Huxley St. Apartments Urban Design Commission Hearing

July 1, 2026

UDC Comments

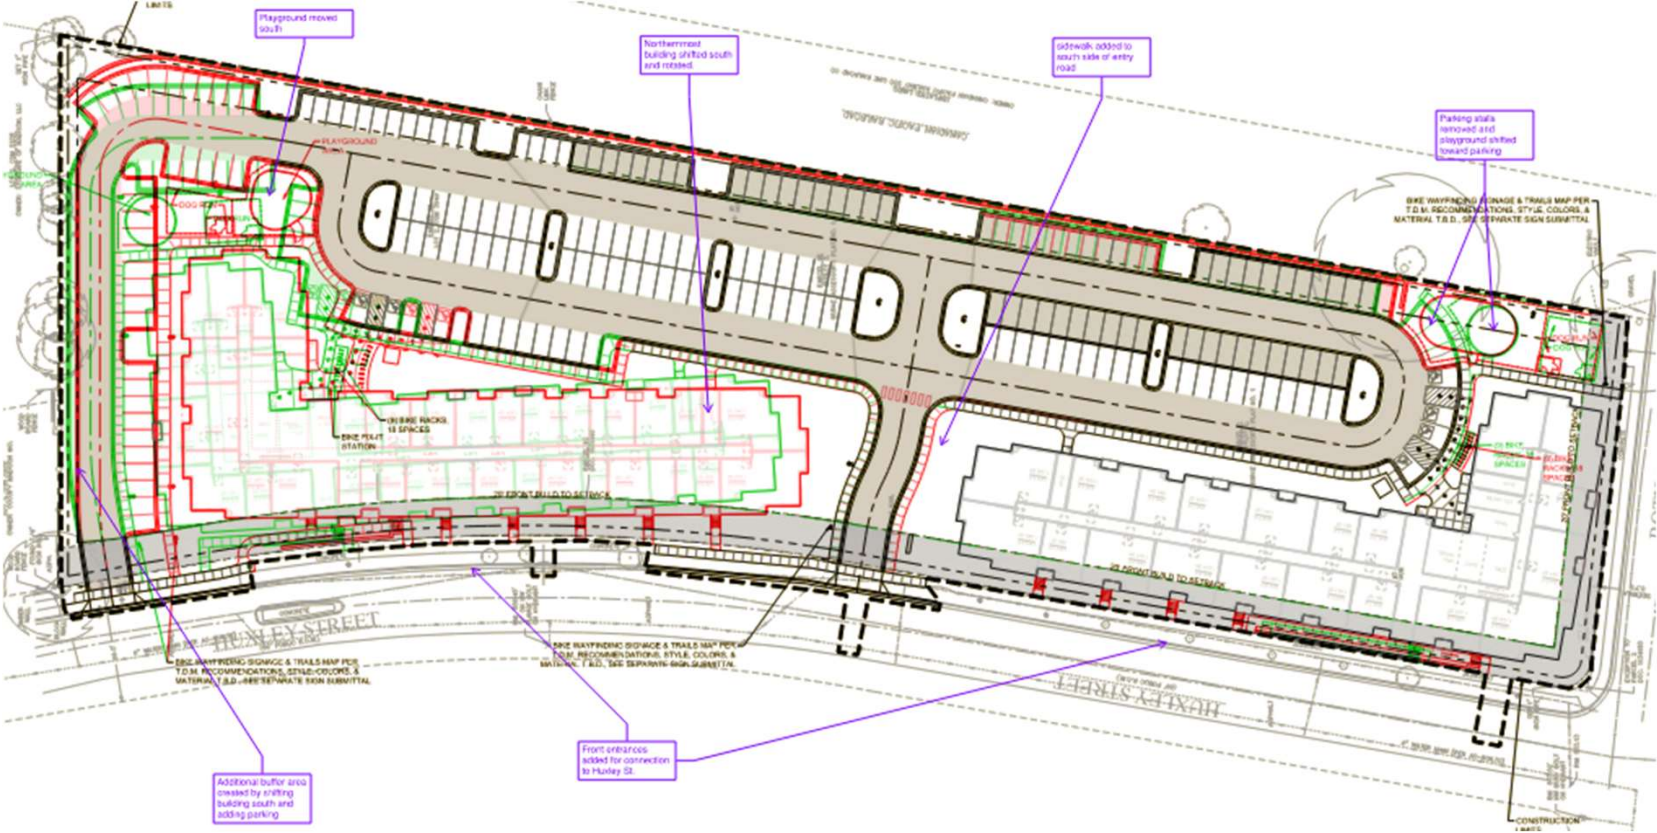
- Revise the building design to maintain the datum lines and consistent materials on the base, middle, top, and decreasing repetitive patterns;
- Incorporate individual walk-up units along the first floor to create more of a connection to Huxley Street;
- The landscape plan shall be revised to replace the eastern red cedar with another evergreen and the red maples located in the asphalt paving with a different species (i.e., swap white oaks or red oaks in those areas), and reflect natural shredded hardwood bark mulch;
- Provide fencing details;
- Revise the site plan to shift the northern-most building south to create more of a buffer along the north property line, different locations for the playgrounds, and providing more of a landscape buffer treatment along the railroad edge.

Changes to Landscape Plan

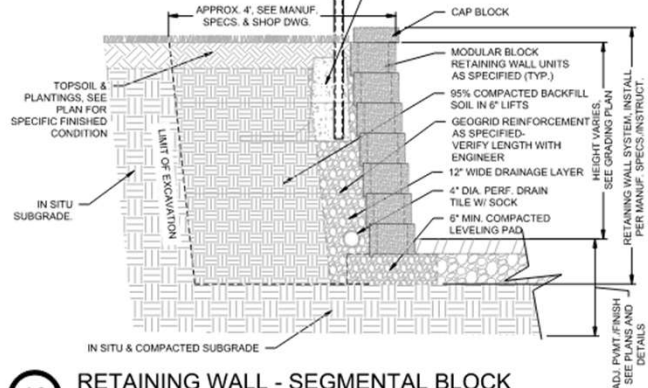
The landscape plan has been revised per UDC comments.

- The landscape plan has been revised to provide additional plant material along the north property line. These large shrubs and evergreens, along with the existing adjacent fence and overstory trees should provide additional multi-level screening between the two properties.
- We have substituted Cupressina Norway Spruce (*Picea abies* 'Cupressina') for the original Eastern Red Cedars and Swamp White Oaks (*Quercus bicolor*) for the original Red Maple species.
- Wherever used, we are specifying non-dyed shredded mulch.
- We have added additional overstory trees throughout the parking lot islands along the east property line.
